Chicken Salad Chick Exterior Elevations & Signage STAFF REPORT

Petition Number: 2021-0001 ARB

Request: Architectural Review Board approval for the exterior modifications to existing restaurant outparcel known as Parcel C4 (aka Chicken Salad Chick) within the Pines of Wellington Tract C Replat (aka Wellington Commons Mall) and signage with technical deviations for the proposed monument sign.

ARCHITECTURAL REVIEW BOARD

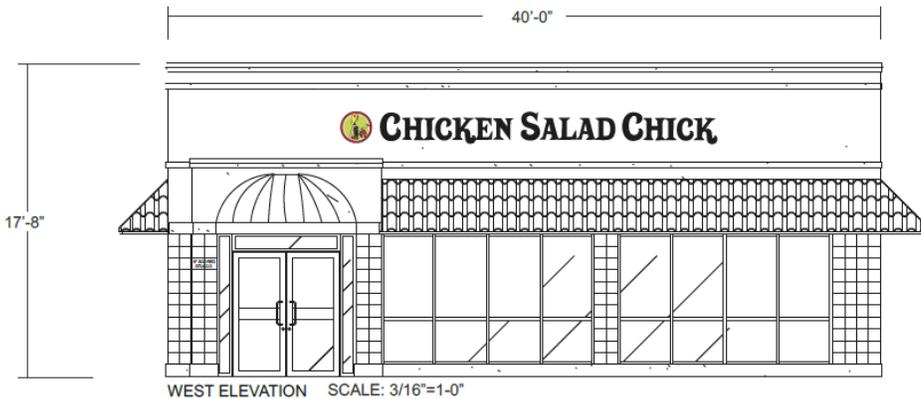
Response: Based on the elevations provided, architectural details have been provided on all sides including trim along the parapet, use of multiple colors, and vertical score lines. Staff recommends the use of vertical score lines and/or continuation of the stone veneer on the east elevation to break up the blank portions of the wall similar to the north and south elevations.

Response: Not applicable as this building is already existing. The applicant is proposing an additional window on the north elevation for a drive thru window.

1. The north, south, and west building elevations shall be constructed as shown in Exhibit E – Proposed Elevations and Wall Signage, and in the colors and materials as shown in Exhibit G – Proposed Colors and Materials. The east elevation shall incorporate additional scoring, stone veneer or other architectural detail approved by ARB.

Primary Wall Sign – West Elevation:

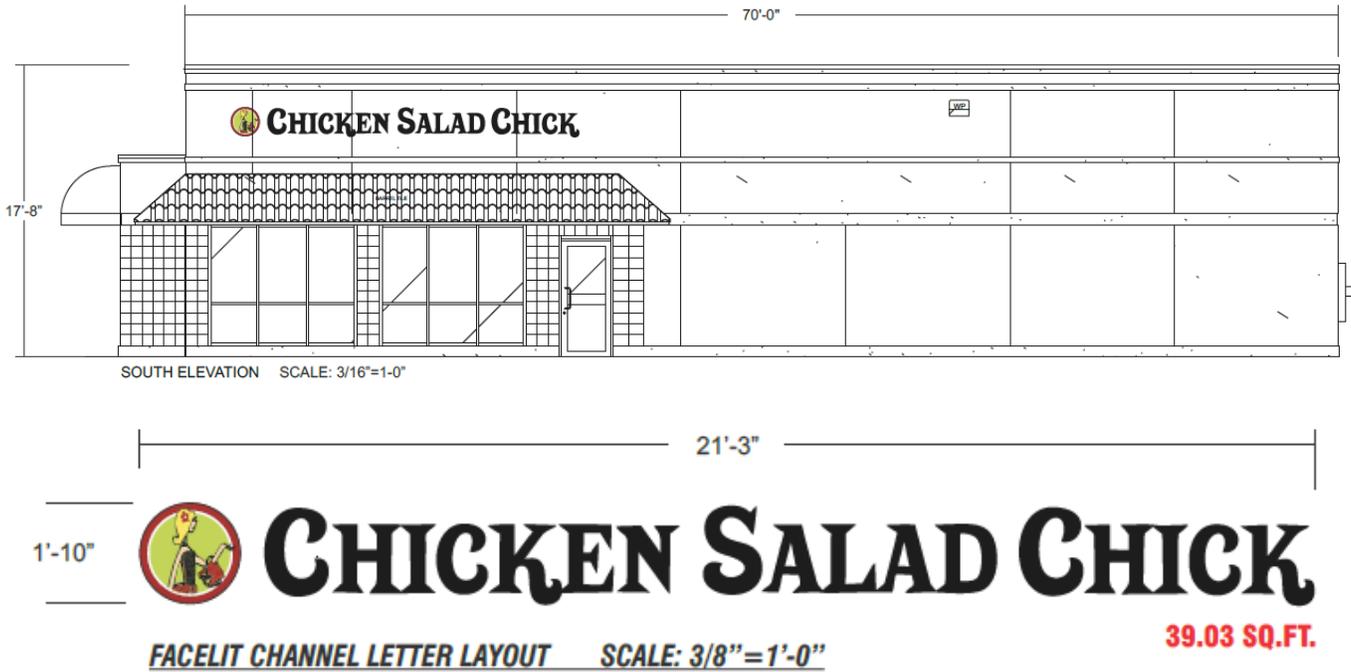
Per Section 7.9.7.A.1 of Wellington's LDR, primary wall signs for minor tenants (tenants less than 5,000 square feet of leasable area) shall be a maximum of 30 inches in height and a maximum length of 80% of the bay not to exceed 150 square feet. The building's primary façade is 40 feet in length allowing the tenant to have a sign with a maximum sign area of 80 square feet.

The proposed sign on the west elevation as shown in Exhibit E is 1 foot 10 inches (1'10") in height and 21 feet 13 inches (21'13") in length for a total of 39.03 square feet. This sign meets the LDR requirements and a technical deviation is not required.

4. The primary and secondary wall sign shall comply with the proposed signs shown in Exhibit E – Proposed Elevations and Wall Signage and meet the following requirements:

- a. Maximum Total Sign Area – 39.03 square feet
 - b. Maximum Height – 1 foot 10 inches
 - c. Maximum Length – 21 feet 3 inches
5. The monument sign shall comply with the proposed size and dimensions as shown in Exhibit J – Proposed Small Monument Sign and meet the requirements below. Staff recommends changing the colors of base of the sign to Greek Villa, Tricorn Black, or a stone veneer to incorporate elements of the building within the sign.

Secondary Wall Sign – South Elevation

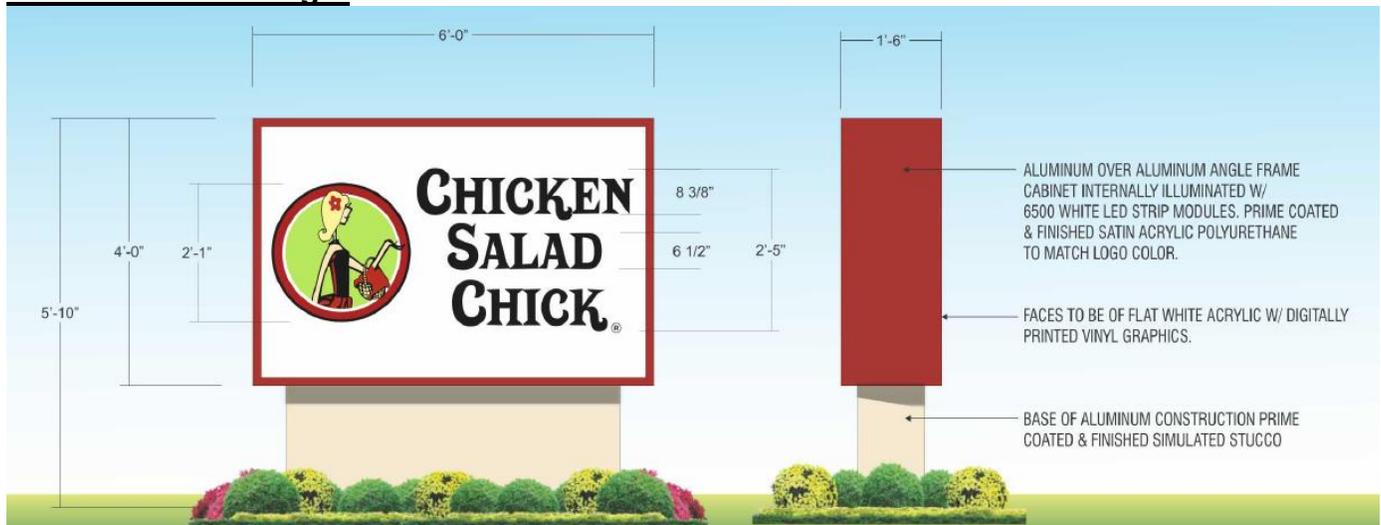
Per Section 7.9.7.A.1.d.i of Wellington's LDR, a secondary wall sign is permitted to be half of the maximum area allowed for the principal wall sign. The maximum sign area of the principal wall sign is 80 square feet, making the maximum area of the secondary wall sign 40 square feet. The proposed sign is also 39.03 square feet, meeting the LDR sign requirements and a technical deviation is not required.

Small Monument Sign:

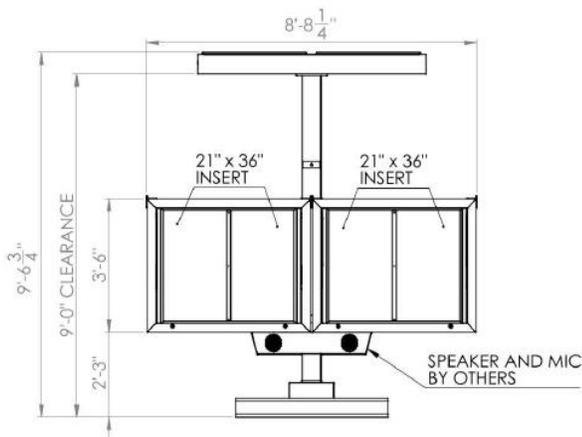
In addition, the LDR requires the sign shall not exceed eight (8) feet in height. The sign copy is limited to two (2) lines of copy, not to exceed 36 inches in height and have a maximum sign area of 32 square feet. The signs shall be separated by a minimum of 200 feet from any other freestanding monument type sign. The proposed sign, as shown in Exhibit K – Proposed Small Monument Sign, is 5’10” in height and six (6) feet in length with a sign copy area of 24 square feet. The sign is proposing three (3) lines of copy, which exceeds the lines of copy by one (1) line. The sign copy text area is 29 inches in height. It is proposed to be located 100 feet from the existing multi-tenant monument sign and 185 feet from the SunTrust Bank sign which does not meet the 200 foot minimum separation requirement. Boston Market previously had a monument sign, but was removed once the business closed. The applicant is proposing the same size and location as where the previous monument sign was located. If the monument sign was not removed, the applicant would not have to request a Technical Deviation for the location. However, because it was removed, the installation of the new monument sign and the additional line of copy will require a Technical Deviation.

The applicant is requesting a technical deviation to reduce the minimum separation requirement between two signs by 100 linear feet from the multi-tenant monument sign and 15 feet from the SunTrust sign and to add an additional line of copy to the monument sign. The monument sign will be installed in the same location as the previous Boston Market's monument sign as it was removed once the tenant vacated the building.

The proposed monument sign as designed does not incorporate the new elements of the proposed elevation of the fast food restaurant. Staff recommends changing the color of the base to the Greek Villa, Tricorn Black, or adding the same stone veneer that is proposed on the building.

- a. Maximum Height – 5 feet 10 inches
 - b. Maximum Length – 6 feet
 - c. Maximum Lines of Copy – 3 (Technical Deviation)
 - d. Sign Area – 24 square feet

- e. Minimum Separation from existing monument sign – 100 feet from Wellington Commons Mall Multi-tenant monument sign and 185 feet from SunTrust Bank monument sign (Technical Deviation)

Auxiliary Ground Signs:

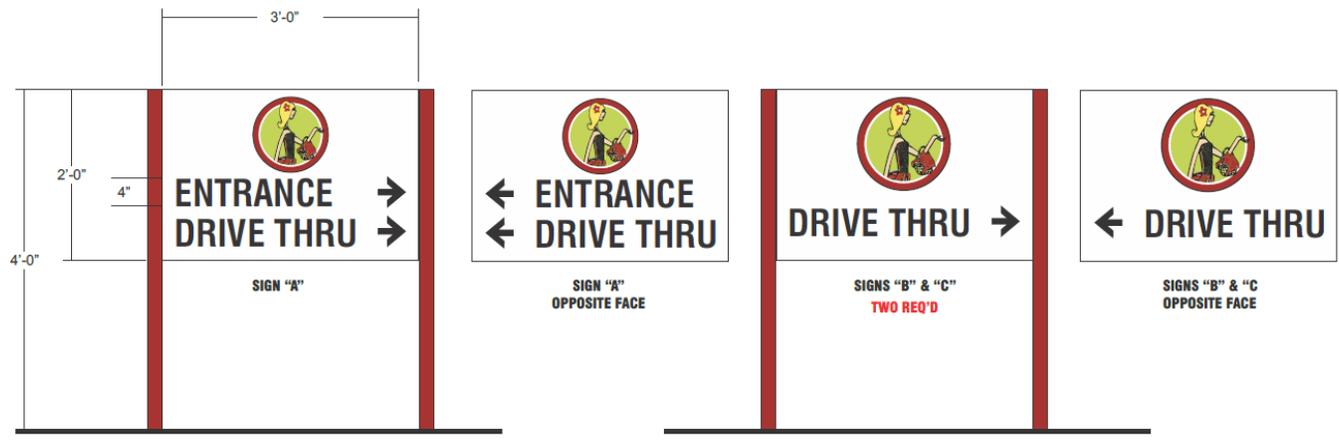
Per Section 7.9.7.B.4 of Wellington’s LDR, one (1) auxiliary ground sign is permitted per lane for a restaurant with a drive-thru with a maximum sign area of 32 square feet. The proposed sign shown in Exhibit L is 8 feet 8.25 inches long and 3 feet 6 inches tall for a total sign area of 30.4 square feet which meets the LDR sign requirement and a technical deviation is not required.

- f. Maximum number of monument signs fronting Forest Hill Boulevard for Wellington Commons Mall – 3
6. The auxiliary ground sign shall comply with the proposed signs shown in Exhibit L – Proposed Auxiliary Ground Sign and meet the following requirements:

- a. Number of signs – 1
 - b. Maximum Total Sign Area – 32 square feet
7. The incidental ground signs shall comply with the proposed signs shown in Exhibit M – Proposed Incidental Ground Signs and meet the following requirements:

Incidental Ground Signs:

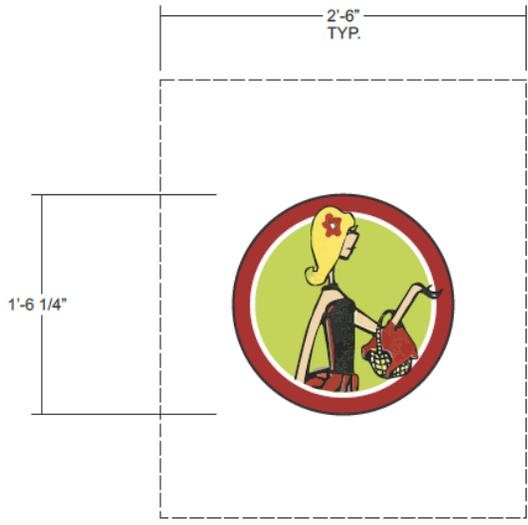
Per Section 7.9.7.B.5 of Wellington’s LDR, one (1) Incidental Ground Sign per critical turning point within 100 feet of a drive-thru facility lane is permitted. Each sign is permitted to be four (4) feet in height with a maximum sign area of 12 square feet. The applicant is proposing three (3) incidental ground signs, as shown in Exhibit M – Proposed Incidental Ground Signs, directing the patrons to the drive thru in the locations shown in Exhibit I. Each sign is four (4) feet in height with a sign area of six (6) square feet which meets the LDR sign requirement and a technical deviation is not required.

- a. Number of signs – 3
 - b. Maximum Height – 4 feet
 - c. Maximum Total Sign Area – not to exceed 12 square feet
8. Window Signage shall comply with the proposed signs shown in Exhibit N – Proposed Window Signage and not exceed 50% of the window area.
